SUBJECT: Repair Program for ACAD/CAM System Drywell and
Suppression Chamber Penetrations

Subject: Repair Program for ADAL/CAM System
Drywell and Suppression Chamber Penetrations

Repair Program
ACAD/CAM System Drywell and
Pressure Suppression Chamber
Penetration Installation
Dresden Station Units 2 and 3
Commonwealth Edison Company

SKETCH OF CAM/ACAD PENETRATIONS

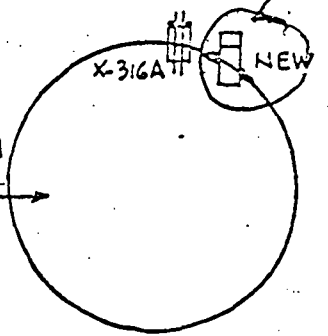
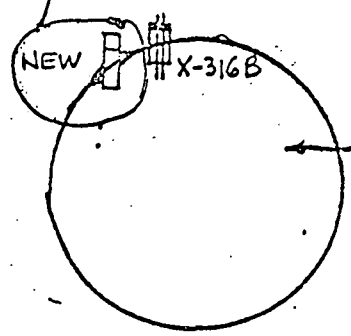
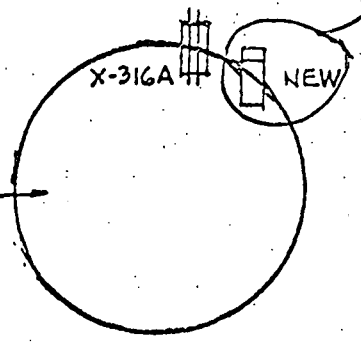
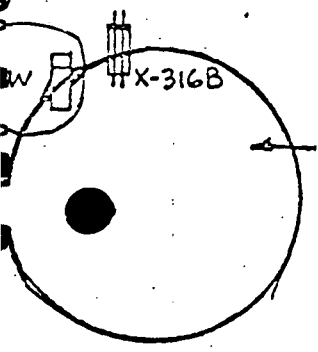
Delete

Delete

Delete

Delete

- ADD END PLATE TO INSIDE END OF EXISTING 12" PENETRATION (FOR RADIATION SENSOR)
- ~~▤ ADD NEW 12" ELECT. PENETRATION SLEEVE INCLUDING WELD NECK FLANGE & REINFORCEMENT PLATE~~
- ▤ ADD 4-1" S.S. PIPES INCLUDING END PLATE TO EXISTING 10" PENETRATION (FOR ACAD & H₂ LINES)
- ▤ ADD 6-1" S.S. PIPES INCLUDING END PLATE TO EXISTING 12" PENETRATION (FOR ACAD, H₂, & PX LINES)

1. The new 12-inch suppression chamber penetration sleeves (2 per unit) have been deleted from the scope of this repair program. (Section I-D of Program) With this deletion any reference to testing for these 12-inch sleeves is also deleted.

4. Pressure Suppression Chamber electrical penetrations shall now consist of 1 inch penetrations utilizing the spare 1 inch pipes being installed in penetrations X-316A and X-316B for Units 2 and 3. These electrical penetrations shall be testable and shall be purchased for this application by the Station Nuclear Engineering Department.
